MODIFICATION INSTRUCTIONS

KODAK MINILOADER 1

MODIFICATION No. M31

PURPOSE:

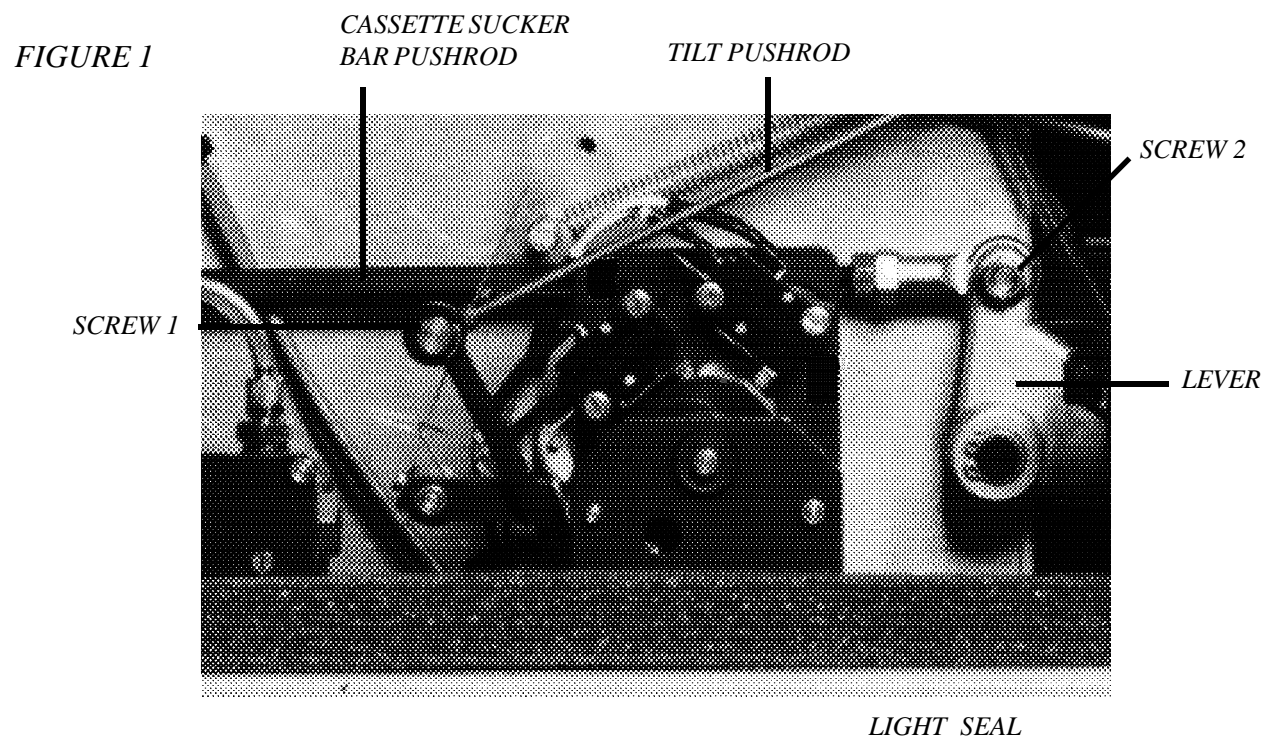
1. Switch off the MINILOADER, and remove the TOP COVER and the left (looking from the front) SIDE PANEL.
2. Disconnect the TILT PUSH ROD by removing the M4 SCREW (SCREW 1 in FIGURE 1) on the TILT LINKAGE.
3. Disconnect the CASSETTE SUCKER BAR PUSH ROD by removing the SCREW (SCREW 2 in FIGURE 1) from the LEVER. CAUTION - support the SUCKER BAR as you remove the SCREW, and gently lower the SUCKER BAR to the CASSETTE CONVEYOR BELT as it becomes loose. Do not attempt to disconnect the CASSETTE SUCKER BAR PUSH ROD by unscrewing the PUSH ROD, as you will destroy the adjustment.

FIGURE 2

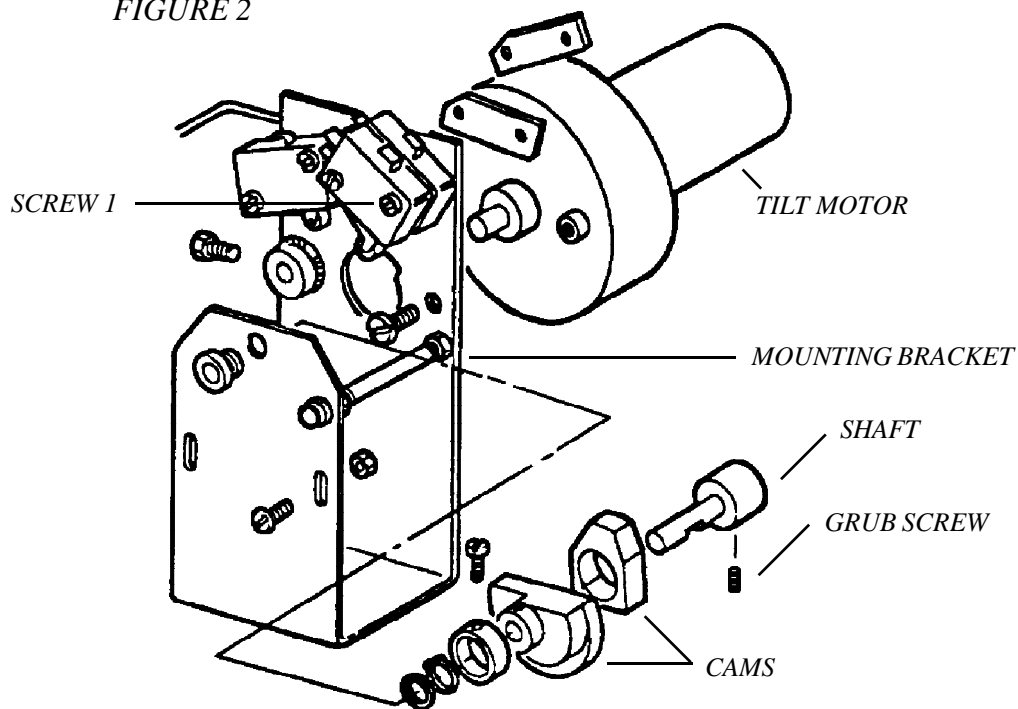
6. Remove the SCREW (1 in FIGURE 2) that retains the two MICROSWITCHES, and then rotate the MICROSWITCHES away from the CAM ASSEMBLY.

7. Remove the three SCREWS that secure the TILT MOTOR to the MOUNTING BRACKET. Hold the CAM FOLLOWERS away from the CAMS and withdraw the TILT MOTOR. The hole in the MOUNTING BRACKET is profiled to allow the withdrawal.
8. Change the existing SHAFT for the new SHAFT, reusing the GRUB SCREW. The new SHAFT has the FLAT for the MICROSWITCH operating CAM advanced by 15 degrees compared to the old SHAFT. This ensures the MICROSWITCHES are operated earlier. Reassemble the TILT MOTOR on the MOUNTING BRACKET.
9. Replace the MICROSWITCH MOUNTING SCREW, and adjust the MICROSWITCHES so the SWITCHES are not bottomed as the CAMS rotate.
10. Refit the TILT MOTOR ASSEMBLY in the MINILOADER and refit the LIGHT SEAL.
11. Refit the CASSETTE SUCKER BAR PUSH ROD onto the LEVER.
